Block C Plot 11 First Street
Manchester

Stage 1 Road Safety Audit

PROJECT REFERENCE: 158834

Stage 2 RSA problem 2.2

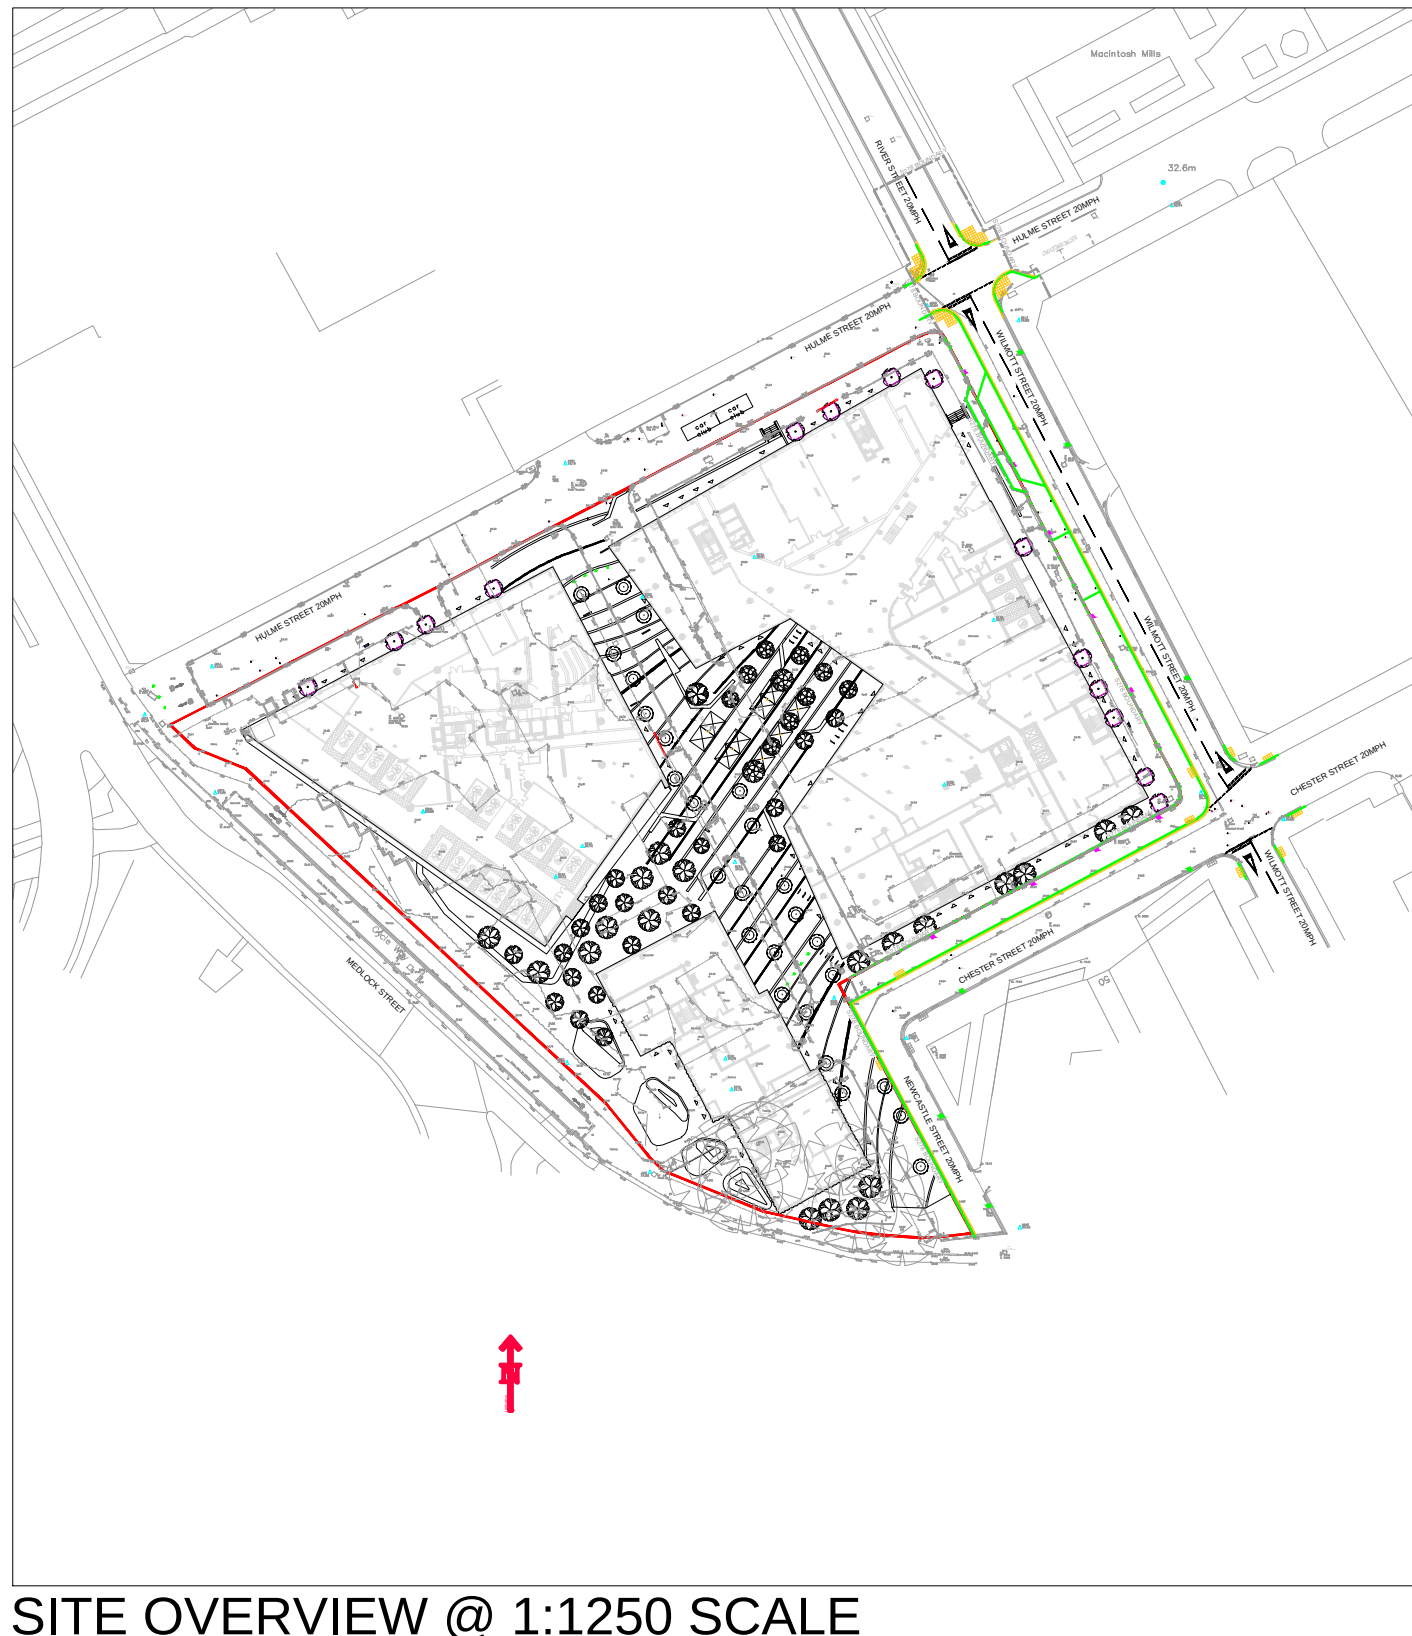
Problem 2.2:

Location: Wilmott Street just south of Hulme Street

Summary: No details of street lighting have been provided on the drawings for the west side of Wilmott Street or along the northern side of Chester Street. There are 3 street lights on the east side of Wilmott Street at a wide spacing with one previously on the east side at the junction of Chester Street (since removed). There is 1 street light on the southern side of Chester Street with one on the western end adjacent to Newcastle Street together with 1 on the northern side (since removed). The development will lead to vehicles manoeuvring along Wilmott Street and into the loading bay and accessible parking bays together with an increase in resident footfall. Inadequate lighting levels could lead to the increased risk of conflicts between vehicles and also between vehicles and pedestrians.

Recommendation: Provide appropriate lighting levels on Wilmott Street and Chester Street to accommodate the increased pedestrian activity.
